Access Compliance Report

Public Rights-of-Way

(Curb Ramps)

Intersection ID: 10029119	Main Street: JAMES_BLAKENEY_AV	Cross Street: N/A	Location: NE
ADA ID: 2D524F38DD35	Ramp Type: PerpDiag	Initial Pass/Fail: Fail	Overall Compliance: No
Severity Score: 13.75			
Codes/Mitigation Info/Possible Solution		Field Measurements/Component Compliance

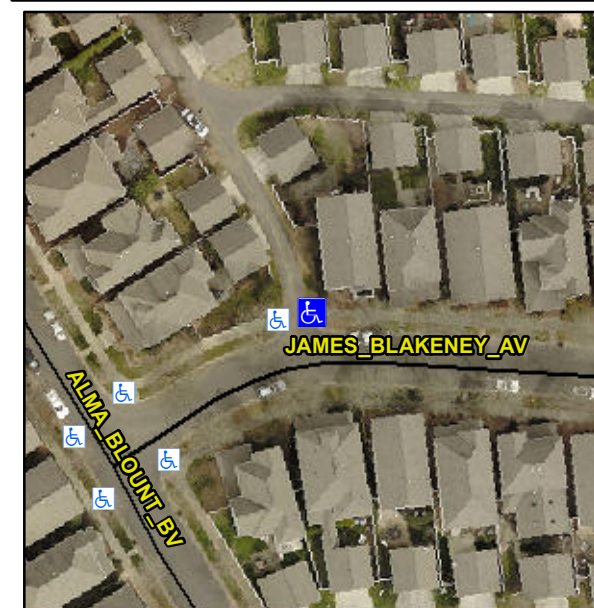
R304.2.2, R304.5.3

Compliance	Description	Data	Compliance	Description	Data
N/A	Ramp Length (in)	53.0	No	Ramp Slope (%)	10.6
Yes	Ramp Width (in)	53.0	No	Ramp XSlope (%)	2.7
N/A	Flare Type LT	N/A	N/A	Flare Type RT	N/A
N/A	Flare Slope LT (%)	N/A	N/A	Flare Slope RT (%)	N/A
N/A	Flare Traversable LT?	N/A	N/A	Flare Traversable RT?	N/A
N/A	Landing Length (in)	N/A	N/A	DWS Provided?	N/A
N/A	Landing Width (in)	N/A	N/A	DWS Contrast?	N/A
N/A	Landing Slope (%)	N/A	N/A	DWS Length (in)	N/A
N/A	Landing X Slope (%)	N/A	N/A	DWS Full Width?	N/A
N/A	Landing Curb? (Y/N)	N/A	N/A	DWS Offset (in)	N/A
N/A	Shared Landing?	N/A			
N/A	Gutter Ponding?	N/A	N/A	Gutter Slope (%)	N/A
N/A	Gutter Lip Ht (in)	N/A	N/A	Gutter X Slope (%)	N/A
N/A	Painted X Walk1?	No	N/A	Painted X Walk2?	No
	X Walk 1 Direction	To W		X Walk 2 Direction	To S
N/A	X Walk 1 Width (in)	N/A	N/A	X Walk 2 Width (in)	N/A
	X Walk 1 Slope (%)	0.4		X Walk 2 Slope (%)	1.4
	X Walk 1 X Slope (%)	1.3		X Walk 2 X Slope (%)	4.7

Remove & Replace Curb Ramp With Two New Directional Ramps or Equivalent.
